Technical Memorandum

Review of Underground Injection Control Permit and Application Gunnison Copper Project

January 6, 2017

Draoon, Arizona

Figure 13: Figure 32 from CCA (2016) Attachment A-2 showing the calibrated steady state recharge rates around the model domain.

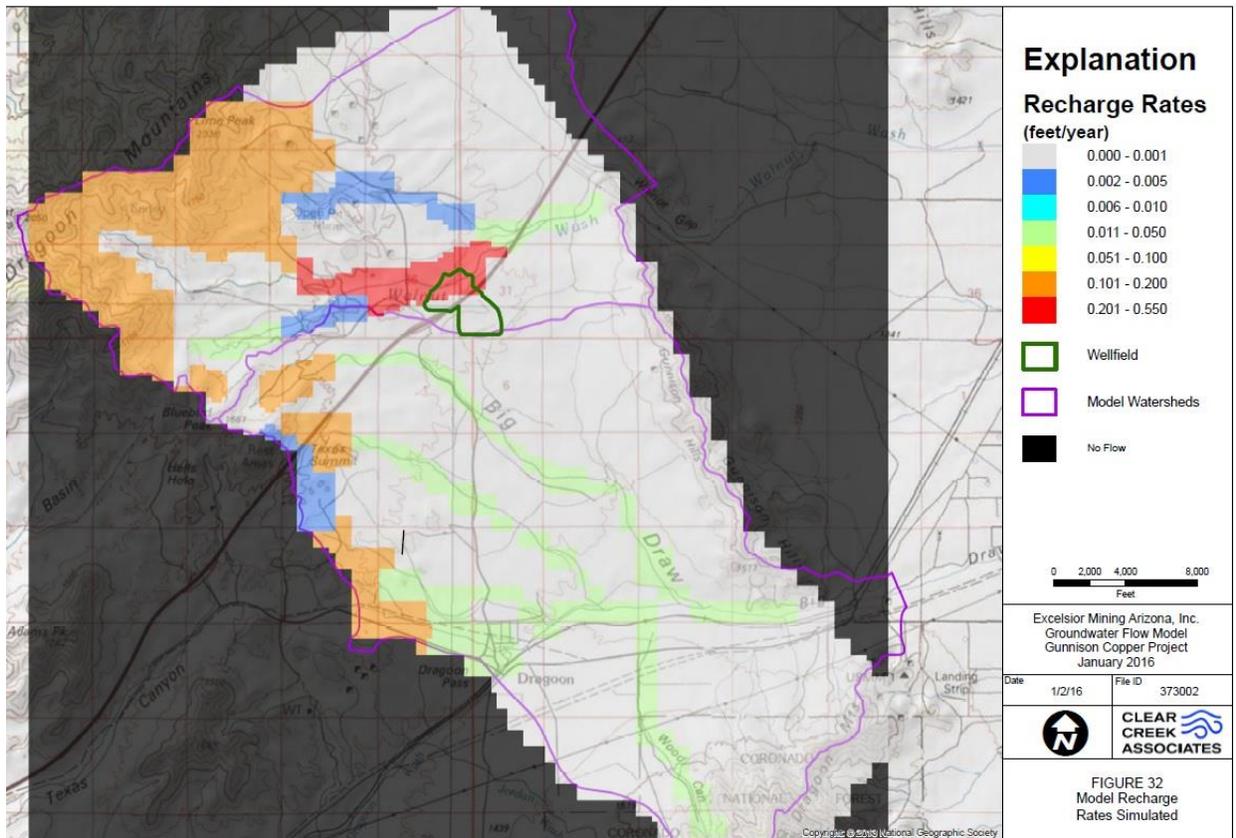
As part of calibration, the modelers distributed the total recharge around the model domain (Figure 13). The noncolored area on Figure 13, which is most of the domain away from the mountains and washes, represents recharge less than 0.012 in/y.

The concentrated recharge may significantly bias the model results. The large zone in orange, west of the project site in the Little Dragoon Mountains, is recharge from 1.2 to 2.4 in/y (Figure 13). Recharge would enter the groundwater in this mountain block only if the geology is highly fractured at the surface, otherwise the area should mostly generate runoff. Much of those mountains have the second highest conductivity values (Figure 14), possibly due to the calibration.

Walnut Wash is a substantial drainage which flows east from these mountains, which indicates there is substantial runoff from the mountains. The model simulates from 0.55 to 6.6 in/y near Walnut Wash west of and within and north of the north quarter of the wellfield. The area is almost 2000 feet wide and over 6000 feet long. The recharge rate into the model domain through the Walnut Wash area is very high, the product of the rate and area shown in red. Most other areas that represent washes are simulated with recharge from 0.12 to 0.5 in/y (green).

Only the smallest recharge rate is used for recharge in the Dragoon Mountains in the southeast. Even if the geology is not conducive to distributed recharge, there should be runoff that leads to mountain-front recharge.

As a result, the calibrated conductivity near the wellfield could be artificially too high. This would cause simulated flow through the area, both regional flow and injected flow to be channeled through large preferential flow areas which would prevent it from flowing away from the well field. Essentially this recharge distribution could channel flow away from Driagoon and other areas, thereby causing the model to not estimate impacts to groundwater users near Driagoon.

Figure 14: Figure 21 from CCA (2016) Attachment A-2 showing conductivity in model layer 1, the uppermost layer in the model.

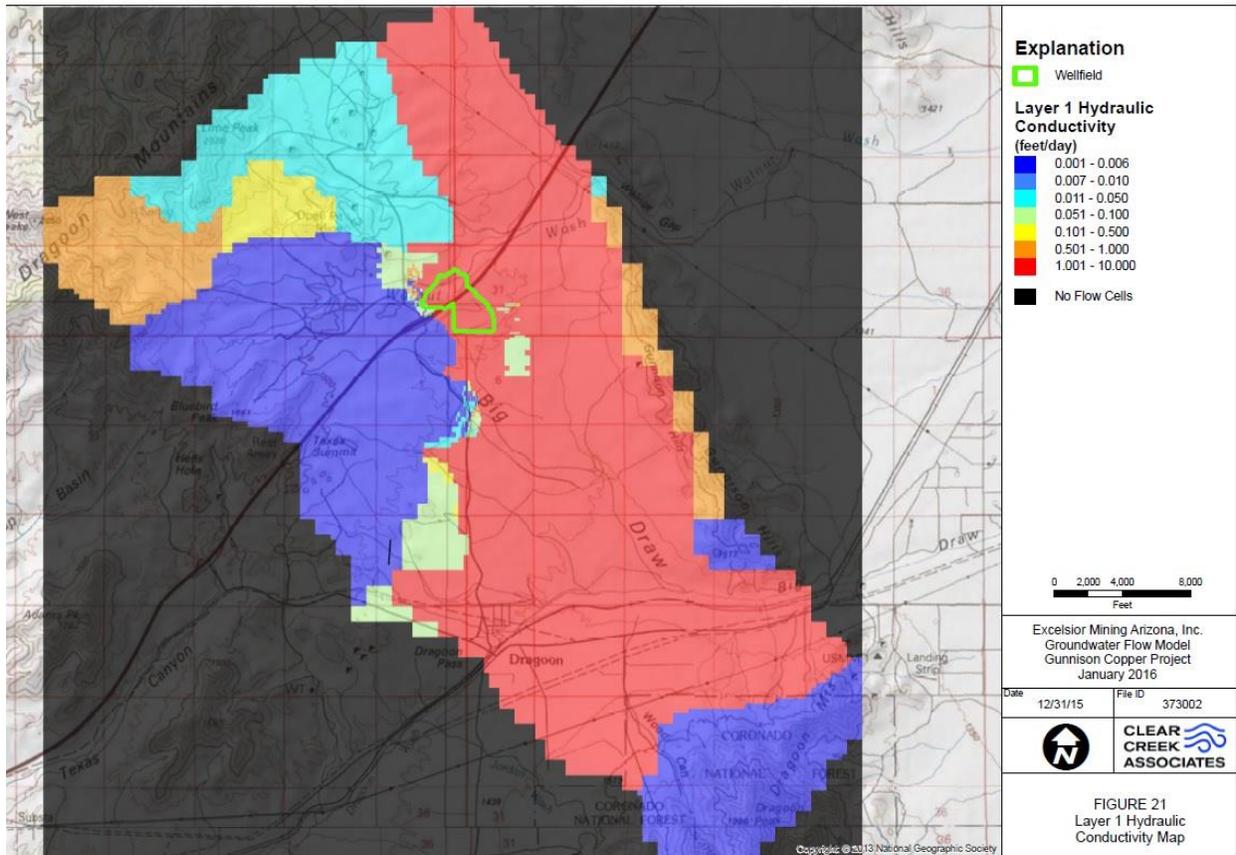
The low K in model layer 1 west of the well field (Figure 14) coincides with the high recharge in the Walnut Wash (Figure 13). This causes the higher groundwater ridge and steep slopes seen in the modeled steady state contours (Figure 15). Much of the remainder of the high recharge zones west of the project coincides with higher conductivity material in layer 1.

Figure 15: Figure 33 from Attachment A-2 showing groundwater elevation contours, residuals at observation wells, and residual statistics.

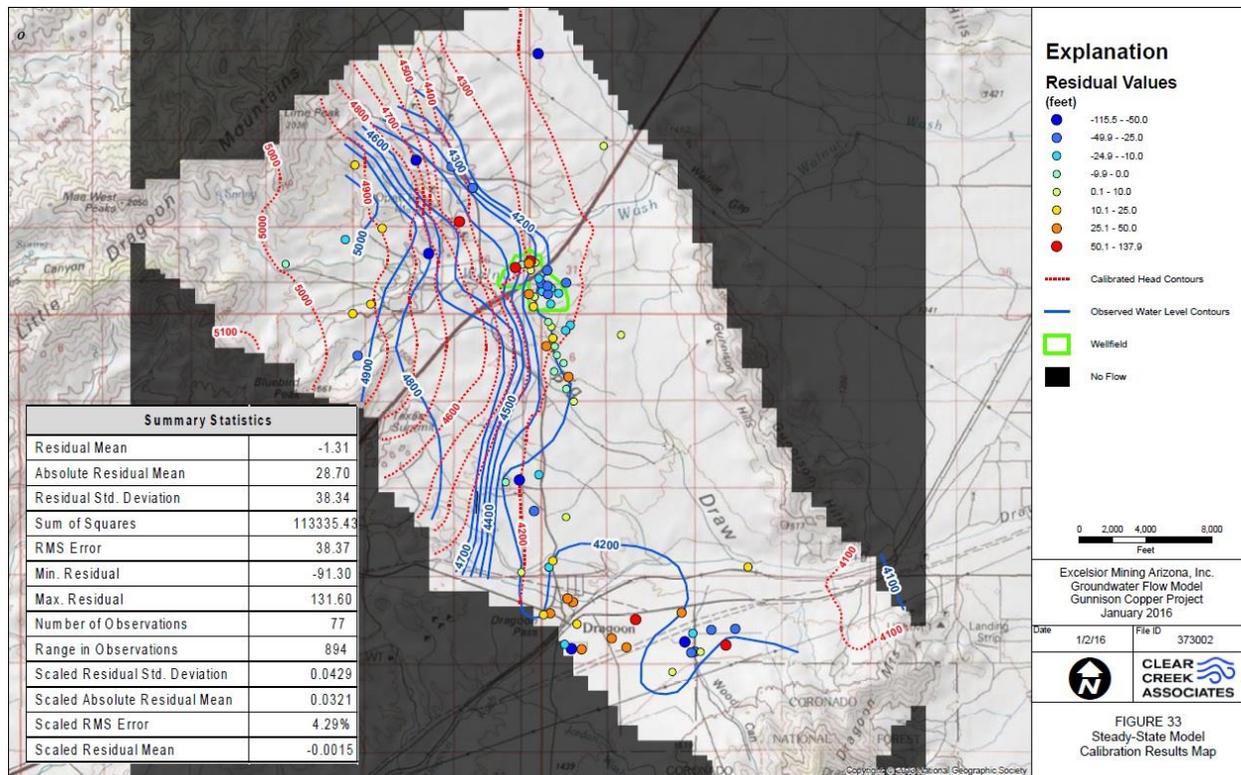
Figure 15 shows simulated and observed groundwater contours and residuals resulting from the final calibration. A residual is the difference between simulated and observed values. The simulated heads have a much more consistent gradient and resemble a surface much more than the observed heads. This probably reflects how the model layers represent average values over several fracture zones whereas the observation wells are monitoring different fracture zones. Simulated contour 4200 ft lies a couple thousand feet east of the observed 4200 ft contour which means the simulation results in a potentiometric surface above the observed.

The residuals through the wellfield area transition from high positive values, 50.1 to 137.9 with red circles to high negative values, -115.5 to -50.0 with blue circles over a short distance. The simulated potentiometric surface resembles an eastward dipping plane through a water table that is both far above and far below the plane. This could be the result of a flow barrier that causes the actual water levels to drop but is not included in the model or trying to match observed water levels from aquifers that are not connected. The rapid change in residuals across the site indicate the conceptual model for the area is inaccurate. It could assume connectivity among formations that does not exist, not considering horizontal anisotropy which would cause flow to trend in a certain direction and drop faster in other directions, or assuming more recharge which causes conductivity values that are generally too high. If the fractures trend NW-SE, as noted above, simulated east to west flow would be at an angle to the preferred direction based on fractures.

Figure 17: Figure 36 from Attachment A-2 showing the drawdown from the pump test at well NSH-015.

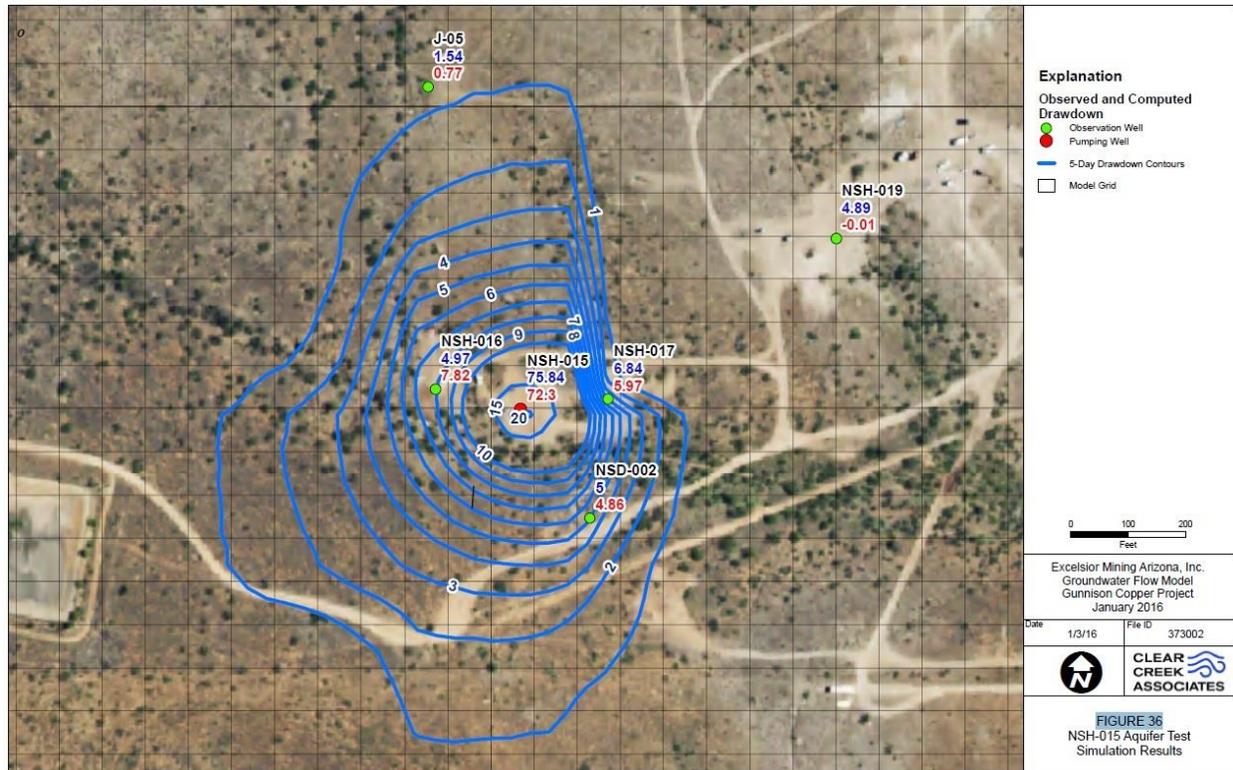
There is little data for transient calibration, which would attempt to match observed water level changes due to a stress applied to the aquifer by changing storage coefficients. The modelers calibrated to data for a pump test at NSH-015, which included a series of four short-term pumping rates followed by a several-day period of constant pumping at 85 gpm. Drawdown at NSH-019 had been predicted to be 4.89 feet but the model simulated just 0.01 feet (Figure 17). This is due to the fracture-dominated flow system and that drawdown depends on the observation well being developed in the same fracture system as the pumping well.

These results demonstrate future problems that will occur with the system. Injection of leachate into a fracture zone that does not have a collection well or a control well will allow flow to exit the system. Figure 17 shows however that there is likely an inappropriate model flow barrier between NSH-015 and NSH-019 since the observed drawdown, as noted 4.89 feet, occurs about 500 feet east of the simulated 1-ft drawdown contour. The simulated material

properties may not connect high K values to create an actual zone. The model cells are much larger than any fracture zone and the fracture intensity would depend on the observed fractures within the cell.

Figure 21: Figure 60 from Attachment A-2 showing the simulated groundwater contours and groundwater velocity vectors for model layer 3, year 21, the end of Stage 3 mining.

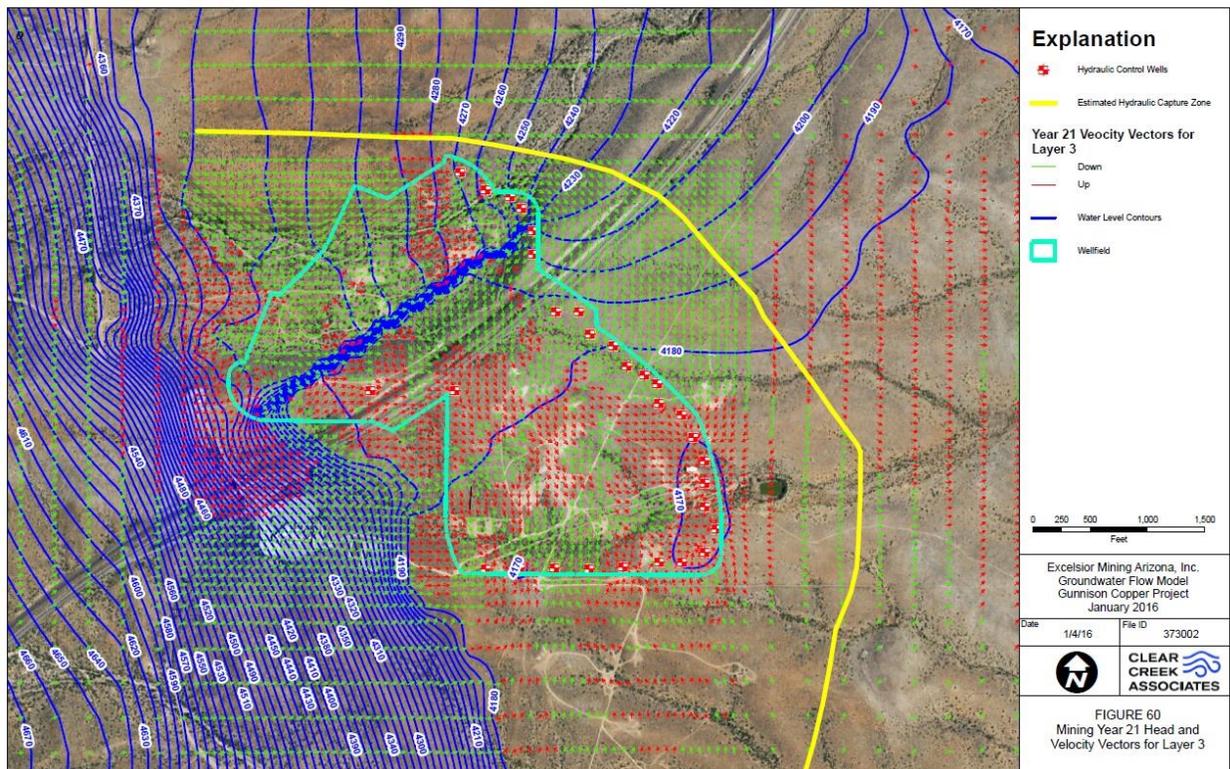
Not all areas within a drawdown cone are areas in which the groundwater flow is toward the middle of the cone. If the baseline groundwater contours dip steeply in one direction, a drawdown may just be a change in slope and the flow may still be away from the cone. Figure 21 shows groundwater velocity vectors (arrows showing direction with the length of the arrow proportional to the speed of groundwater flow) and the groundwater contours (not drawdown) for year 21 (not accounting for injection/collection wells). On the north, west, and south, the groundwater contours naturally slope steeply toward the well field, but in the east and southeast the contours define a relatively flat surface. The surface is so flat that small changes would could cause directional changes in the velocity vectors. The contours in Figure 21 are based on the average head for a specific cell. There is a 4170 contour around the southeast corner of the wellfield delineates a trough in the contours, meaning that simulated flow is to

the center of the trough. Based on the estimated capture zone line, the yellow line on Figure 21 which shows the position of the groundwater divide, the water level is relatively flat throughout the southeast quarter of the wellfield. The mound in the water table represented by the capture zone line is only a few feet higher than the water table in the southeast corner of the project. The pressure at different levels in the groundwater, from the water table surface to a point below the well field, could easily vary from that estimated by consideration only of the water table due to different transmissivity flow paths. Contaminants could escape from the hydraulic control through preferential flow paths through the mapped divide because the average heads in the model cells may not represent actual heads in the fracture zones.

- Drawdown throughout the mining area caused by pumping only the hydraulic control wells is unrealistic. The injection wells would be injecting much more fluid into the system than the hydraulic control wells removed. Of course, the collections wells also remove more, but due to the high injection rates and heterogeneities in the well field, there could easily be high pressure injection into flow paths not otherwise captured by collection wells. The combination of injection and recovery wells would create a

combination of local mounding and drawdown. Due to the volumes and gradients resulting from the injection/collection wells, the hydraulic control well pumping could be overwhelmed. Without simulating the injection/collection wells, this model does not provide reliable information regarding the effect of the injection/recovery system on local or regional flow paths.

- The actual injection/recovery wells should be simulated, with injection rates depending on the localized conductivity and pressures that would be acceptable for operations.
- The model should be discretized into much smaller cells at the mine so that injection/recovery can be simulated more accurately. This could include telescoping the regional model into a much more detailed model at the well field.
- The geology/fracture intensity model should be used at a smaller scale to provide more detail of flow paths through the well field.
- The POC wells should be redesigned according to results from the modeling. The flow model should be used with MT3DMS to simulate transport from the well field to the POC wells. Assuming sources emanating from various positions through the well field, the model could simulate a plume that POC wells should be positioned to detect.

Clear Creek should provide figures similar to Figure 21 for other time periods and for other model layers. Simply maintaining a drawdown is insufficient; it is necessary to maintain a hydraulic low point wherein no flow from the well field can escape into the regional flow field.
